Service Information

SI0345

Equipment Affected: YLAA

YLAA - Brazed Plate HX Freeze Damage - KDD

2. Install New IFM Flow Switch

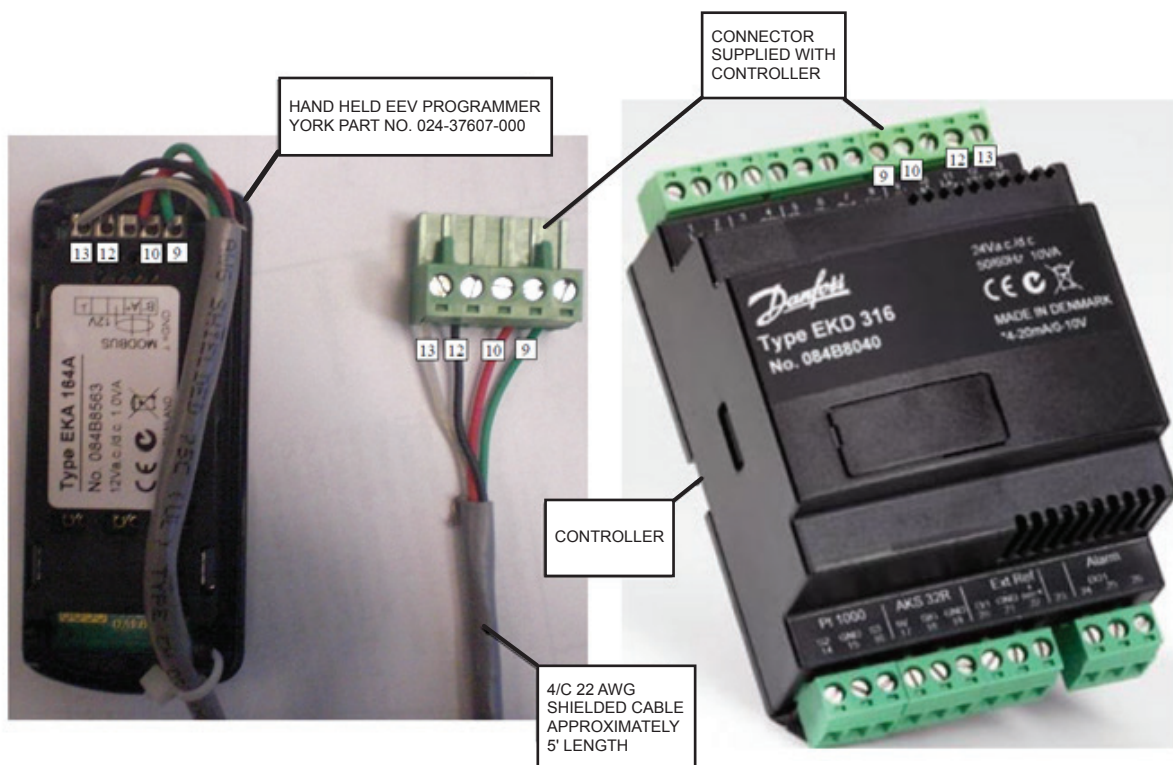
We will provide a new IFM flow sensor that has the close point changed from 20cm/sec to 60cm/sec.

- a. Shut the chiller off and shut the evaporator pump off.
- b. Isolate the chilled liquid flow switch if valves exist.
- c. Disconnect the wiring from the flow switch.
- d. Remove the chilled liquid flow switch and install the new IFM flow switch.
- e. Re-connect the wiring to the new flow switch

PART NUMBER	IFM EFECTOR PART NUMBER	FLOW VELOCITY
025-43553-001	SC0519	60 CM/S

LD22126

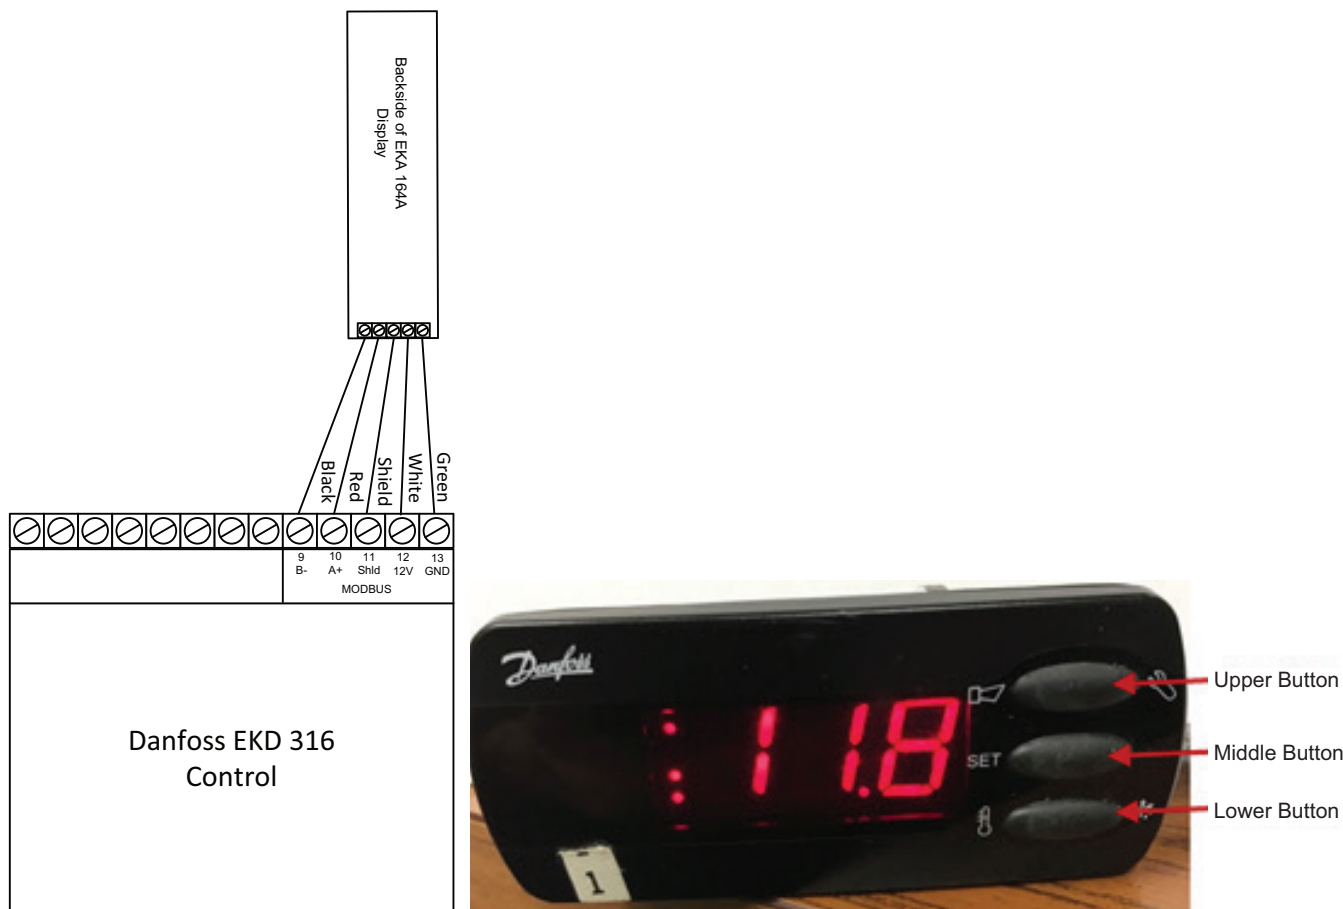
- a. Power off the chiller and connect the Danfoss controller display EKA 164A to the Danfoss control EKD 316 as shown below using a four conductor cable with a shield. Note that the shield is the center terminal on the display and the control.

- b. Power up the chiller and wait for the Danfoss display to complete the ini (Initialization) process.
- c. Press and hold the Danfoss display upper button until the display changes to program mode and **r05** is displayed.
- d. Press the lower display button until the first parameter to be changed **n04** is displayed.
- e. Press the middle display button (SET) to select the parameter to change.
- f. Press the upper button to increase the value or the lower to decrease the setpoint value as needed.
- g. Once the setpoint is set to the desired value, press the middle button (SET) to save the new setpoint.
- h. Press the lower display button until the next parameter to be changed is displayed and then repeat steps 5 through 7.
- i. Set the parameters as shown below.

DESCRIPTION	PARAMETER	CURRENT SETTING	NEW SETTING
P: Amplification factor Kp	n04	2.0	3.0
Max. value of superheat reference	n09	14.4	12.6
Min. value of superheat reference	n10	10.8	9.0
StartUp time (seconds)	n15	0	30
Start OD (%)	n17	0	25
